MONTGOMERY COUNTY HISTORIC PRESERVATION COMMISSION
STAFF REPORT

Address:	9838 Capitol View Ave. (Lot 12, Block 31) Silver Spring	Meeting Date:	9/07/2022
Resource:	Spatial (undeveloped) Capitol View Park Historic District	Report Date:	8/31/2022
Applicant:	Mark Kaufman (Doug Mader, Architect; Phillip Long, Engineer)	Public Notice:	8/24/2022
Review:	HAWP	Staff:	Dan Bruechert
Case No.:	960660	Tax Credit:	n/a
Proposal:	Construction of new single-family residence, site alteration, hardscape alteration, and tree removal

Staff recommends the HPC **approve with two conditions** the HAWP application:

ELEVATIONS

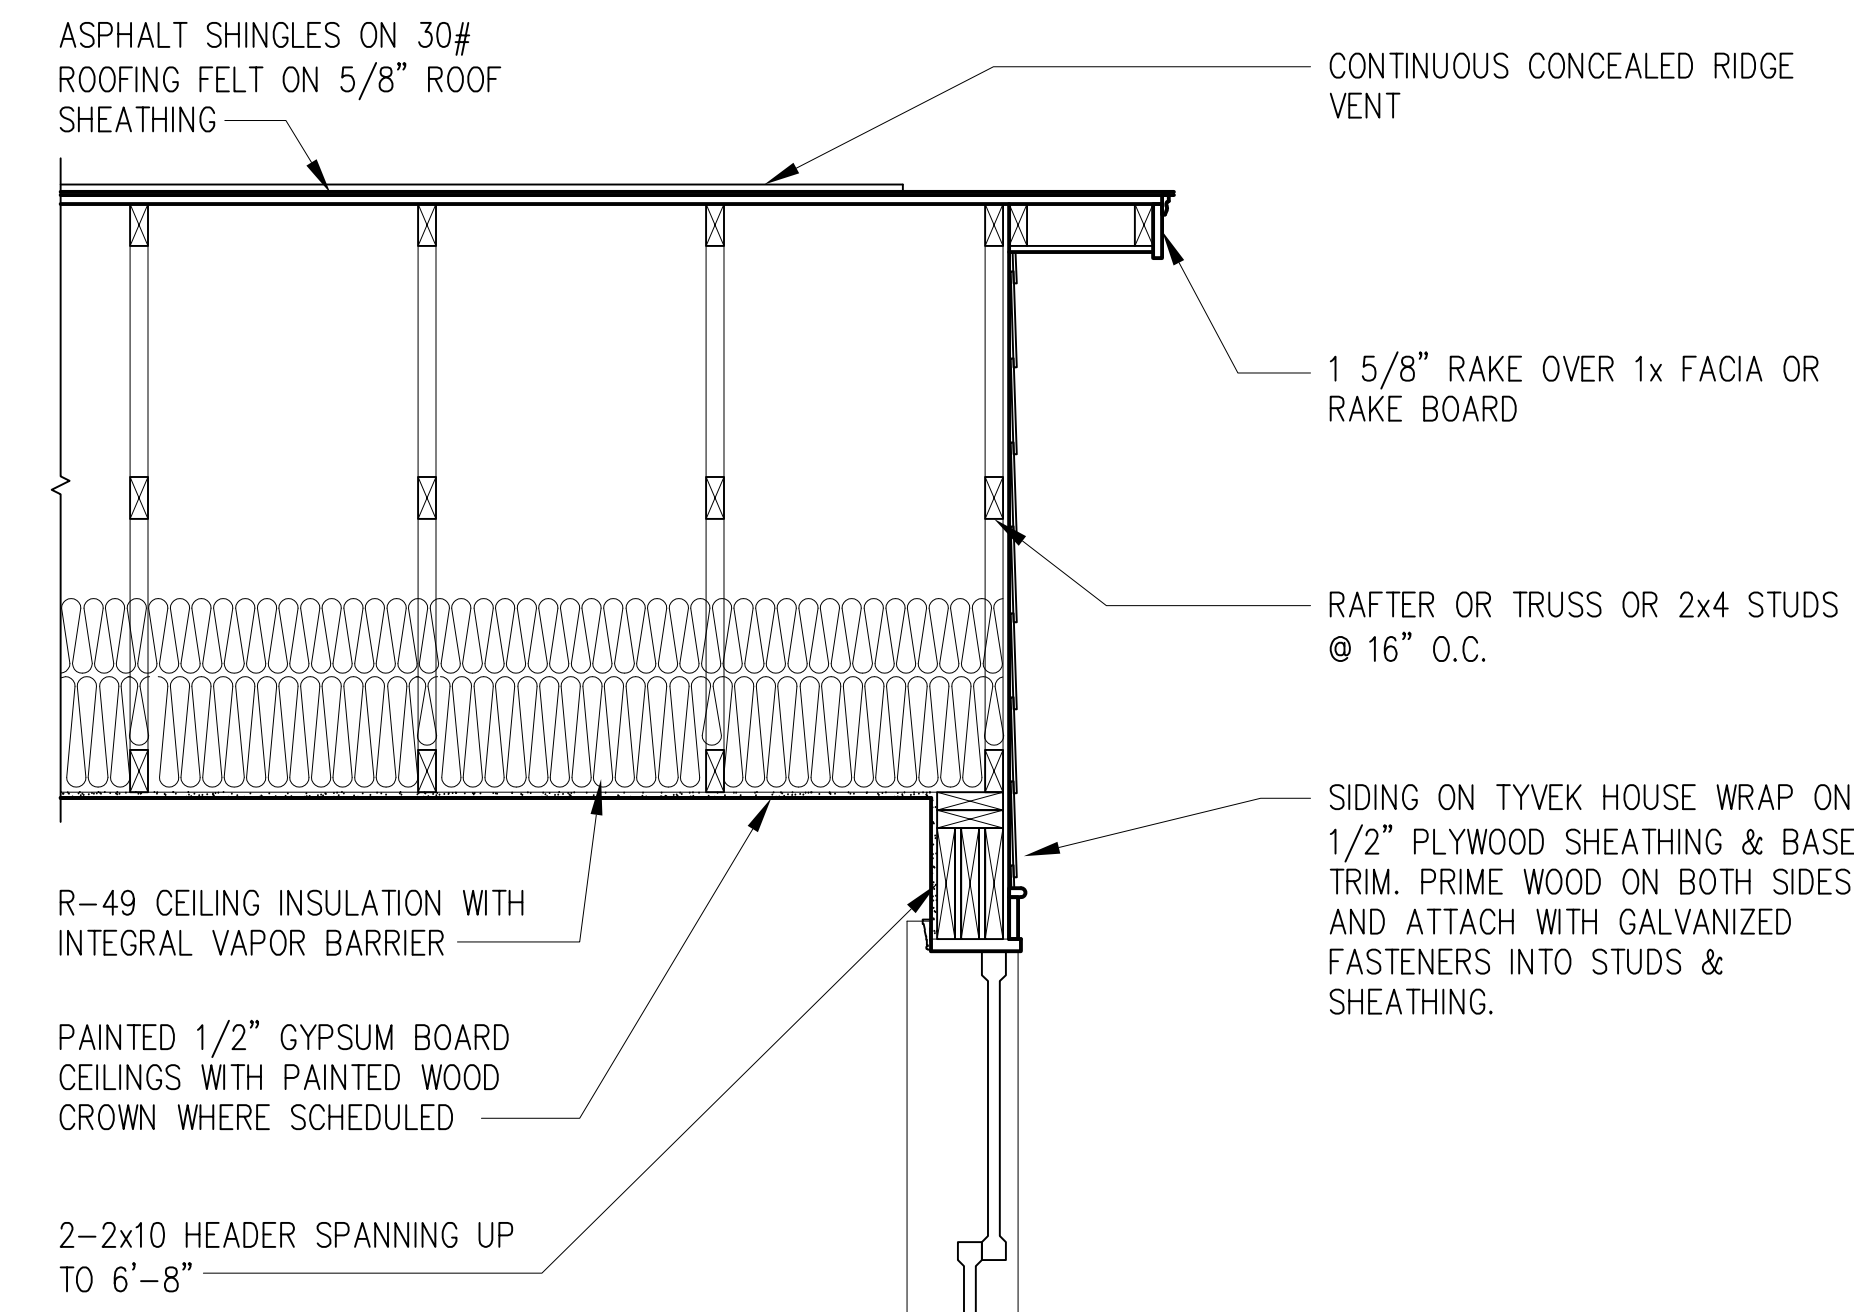
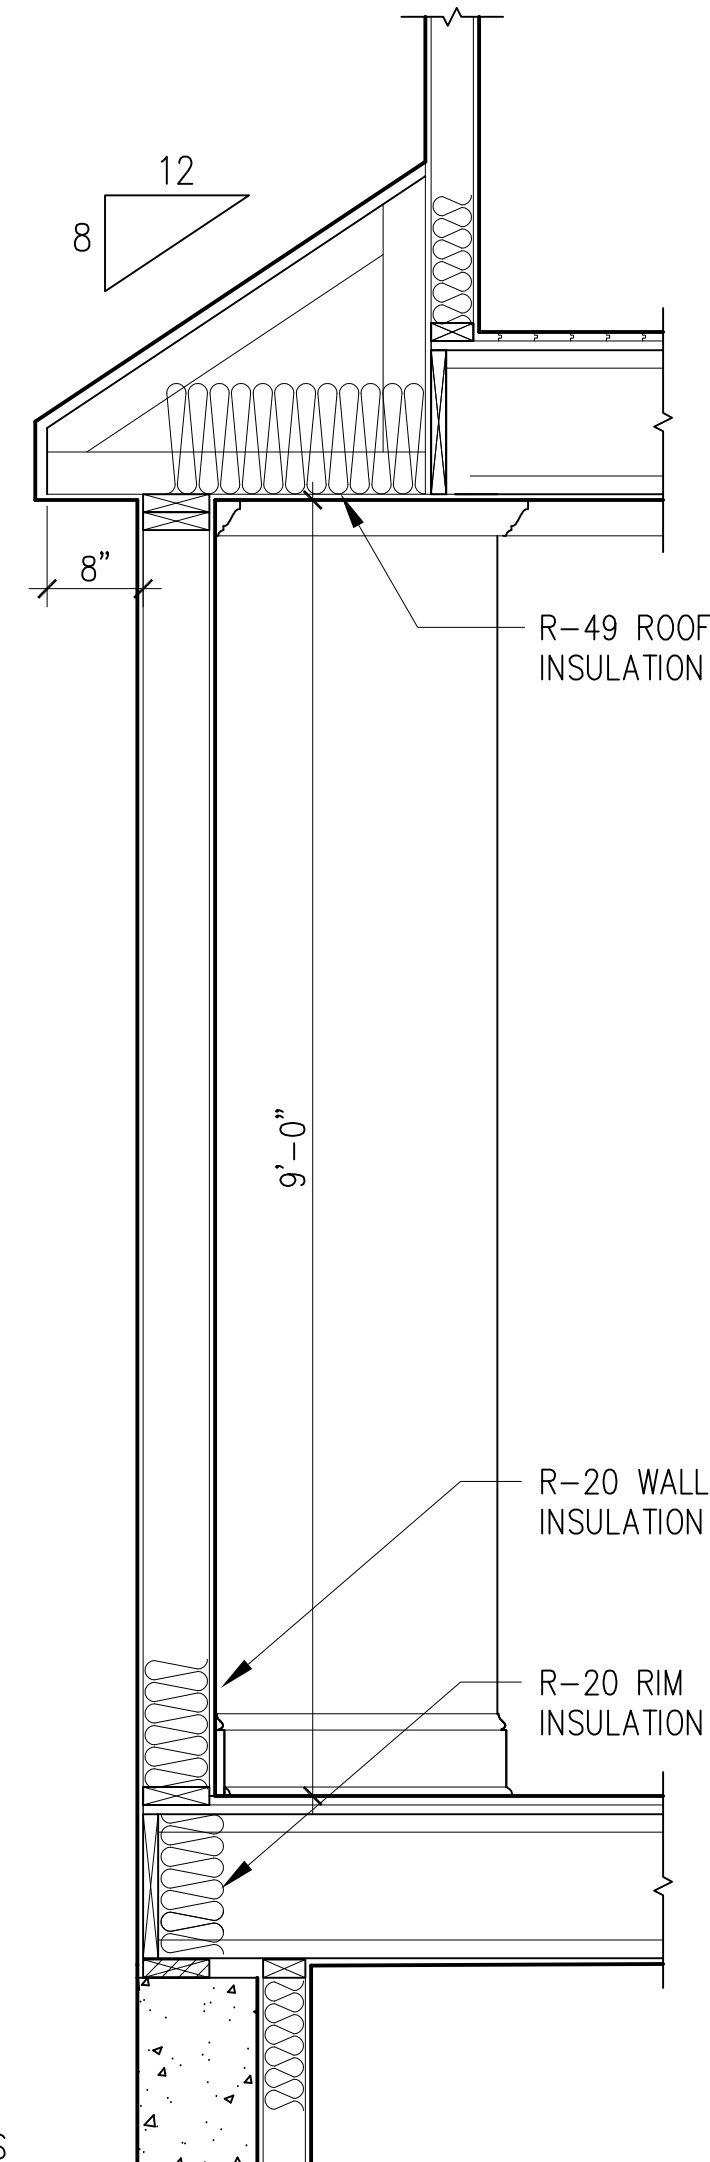
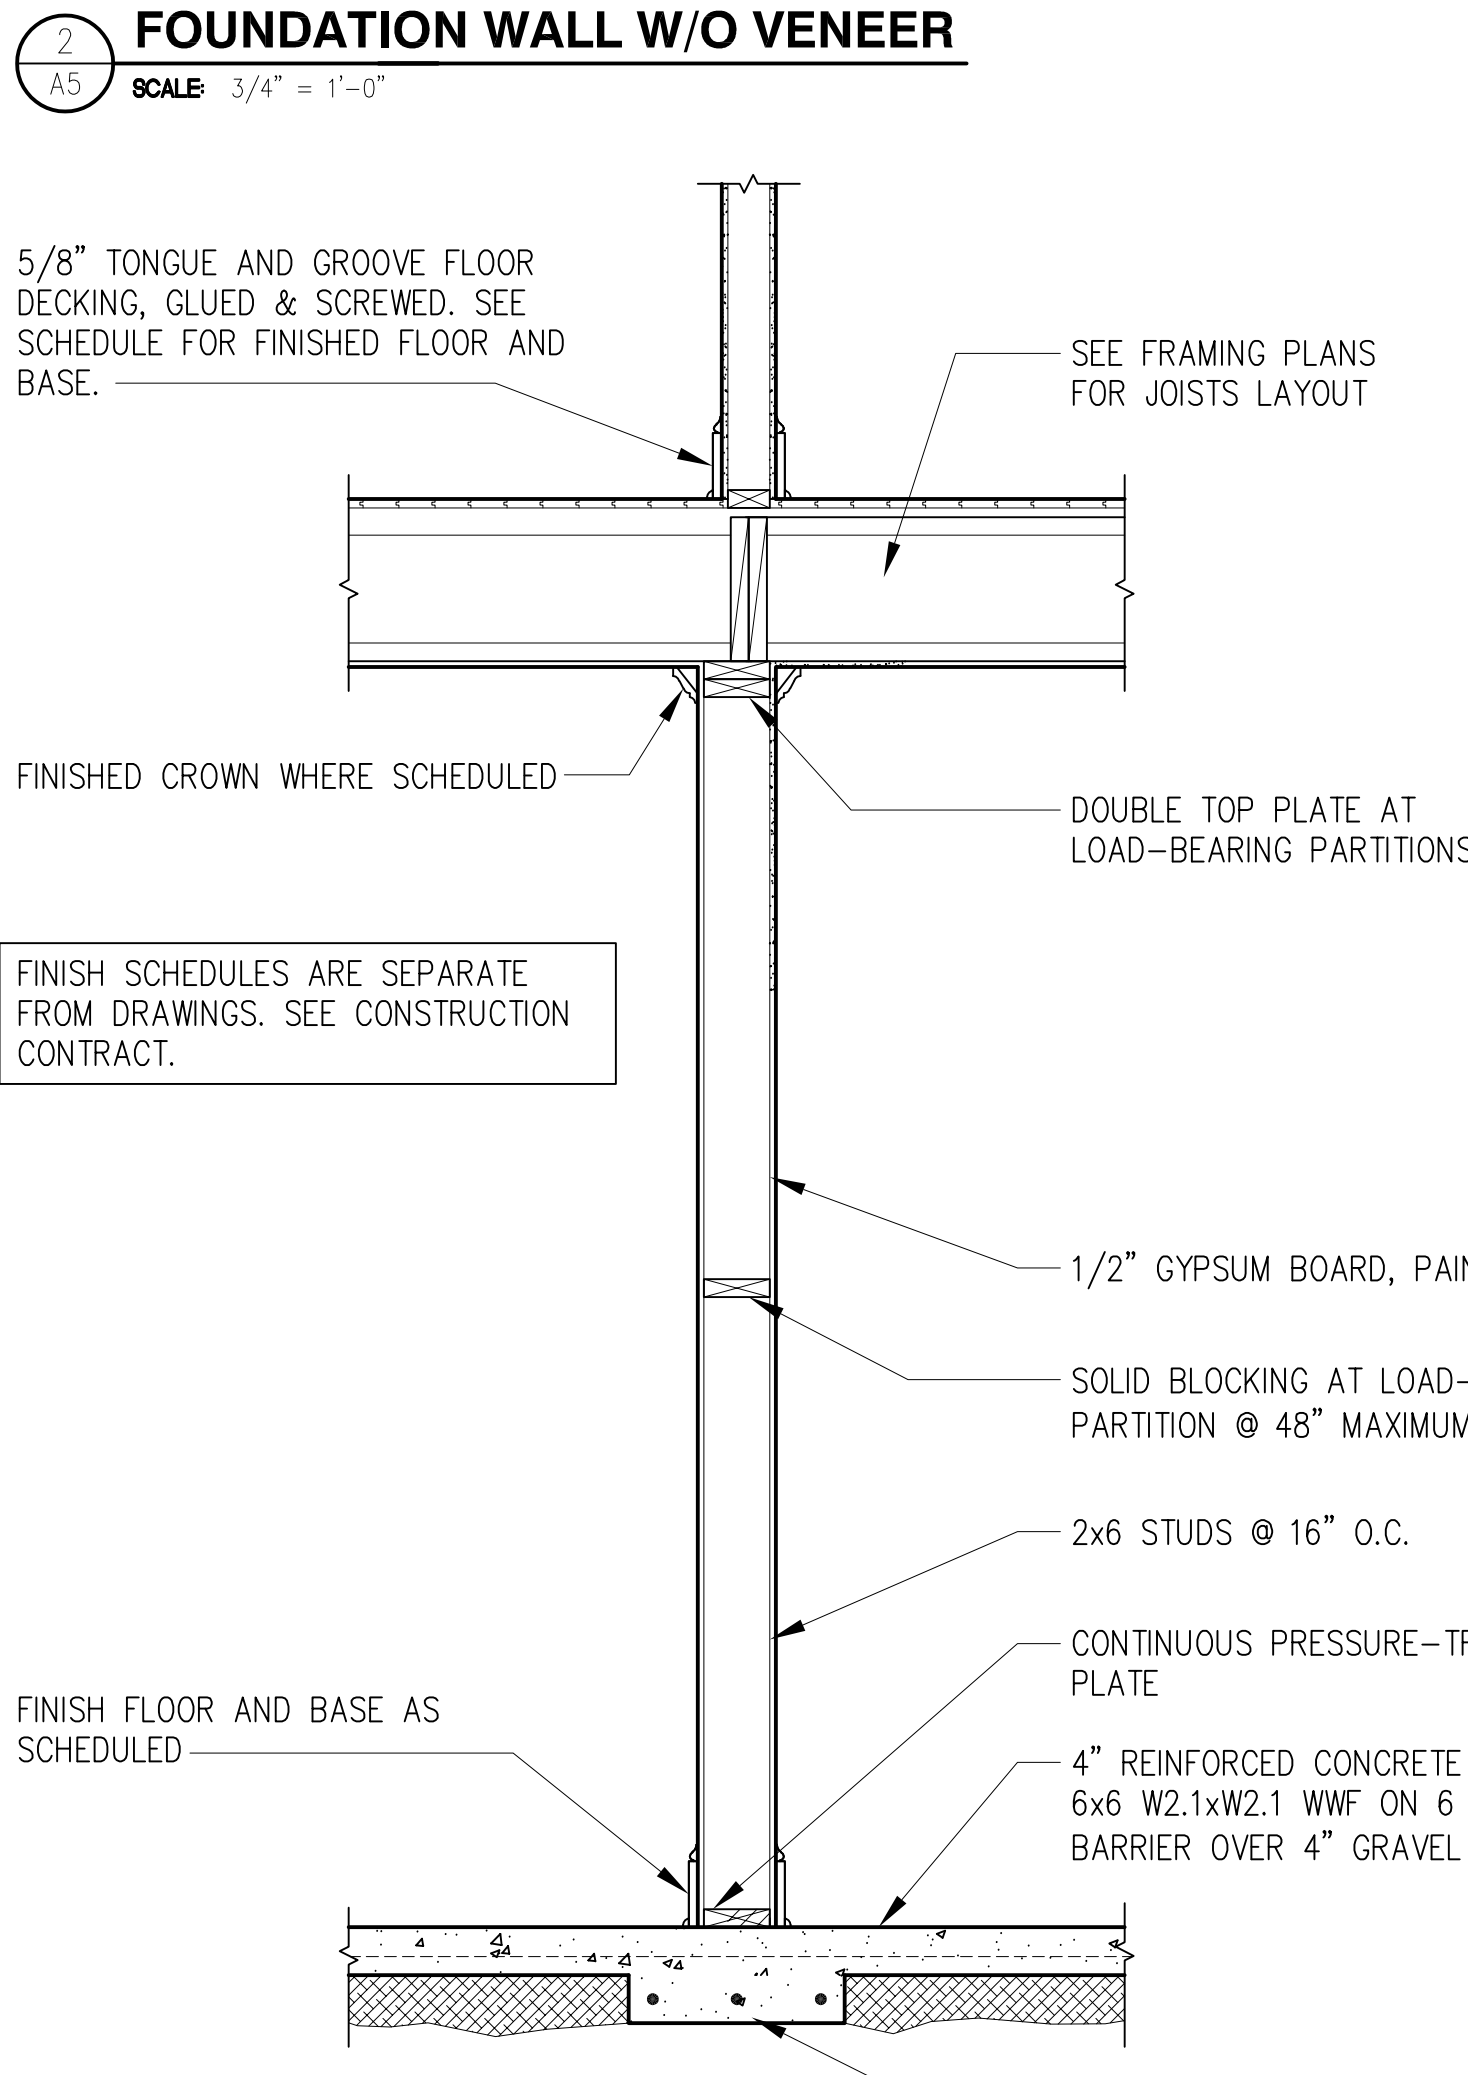
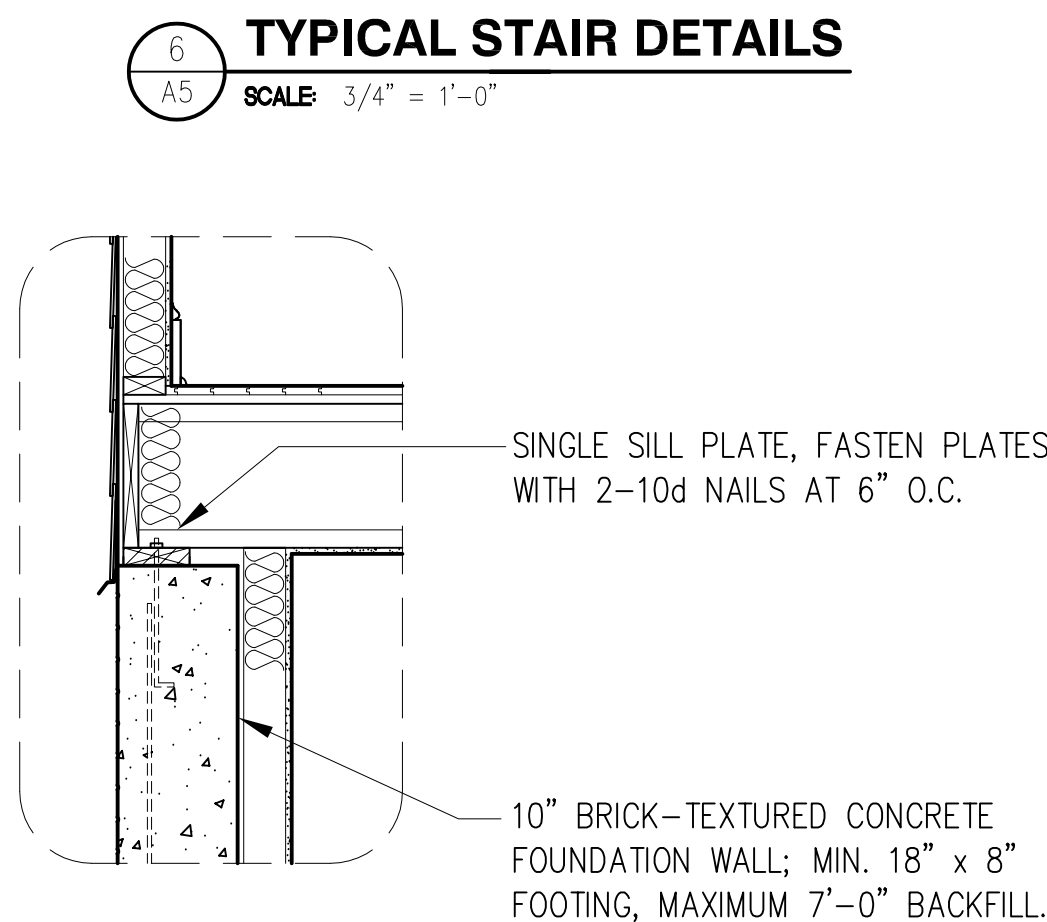
The house is two stories tall and the main block of the house is approximately 35’ × 40’ (thirty-five feet wide by forty feet deep) with a front telescoping, two-car garage that is approximately 20’ × 30’ (twenty feet wide by thirty feet deep). While most of the surrounding houses are one or one and a half stories tall, the proposed two-story construction will not have a significant impact on the streetscape because of the significant change in grade and deep setback. Staff also finds that the proposed house appears slightly wider than many of the neighboring houses on the west side of Capitol View Ave., but not to the extent that it detracts from the surrounding streetscape (see attached streetscape study).

The house draws largely from a traditional architectural vocabulary and have a front gable roof, with a

small front porch with a shed roof. The house has projecting rectangular bays on each side elevations to break up the massing. The proposed house has a large wood deck at the rear. The windows are mostly six-over-one sash windows, with some single lite casements, and picture windows.

The one element that deviates from traditional architectural design is the two-story, front-telescoping attached garage. To accommodate the existing driveway, the house on the subject lot will be front loading with carriage-style doors. At the Preliminary Consultation, Staff found the garage form was not compatible with the surrounding architecture and, absent a compelling reason, should be excluded from the design. During the hearing, the applicant detailed the need to utilize the existing driveway for not only the subject house, and the Carson House, but for the future construction on Lot 13 (to be submitted at a future date).

Staff agrees with the finding of the majority of the Commissioners, that the house is on the large size for the district, but it is not out of character with nor does it overwhelm the houses in the surrounding district. For example, the most recent construction on Capitol View Ave. (9905 Capitol View Ave., approved in 2015) has a footprint of 35' 8" × 50' 11" (thirty-five feet, eight inches wide by fifty feet, eleven inches deep). That construction includes an integrated two-bay garage, which is accessed from Menlo Avenue.

The HPC found the materials proposed are consistent with what is typically approved for infill construction in the Capitol View Historic District. These materials include fiber cement clapboard and fiber cement shingle siding, clad wood windows, and an architectural shingle roof. Staff concurs with the HPC finding that these materials are appropriate for the site and district, however, window specifications were not included with the HAWP submission. Staff recommends the HPC delegate final approval authority for the clad (or wood) windows and doors to Staff.

1. Three shade/canopy trees need to be planted in front of the proposed house, between the house and the public right-of-way. A site/landscape plan satisfying this condition needs to be submitted with the permit drawings before Staff can issue the HAWP approval;
 2. The windows and doors need to be wood or aluminum clad wood. Final approval authority is delegated to Staff to determine the selected windows and doors are appropriate;
- under the Criteria for Issuance in Chapter 24A-8(b)(2), and (d), having found that the proposal is compatible in character with the district and the purposes of Chapter 24A;
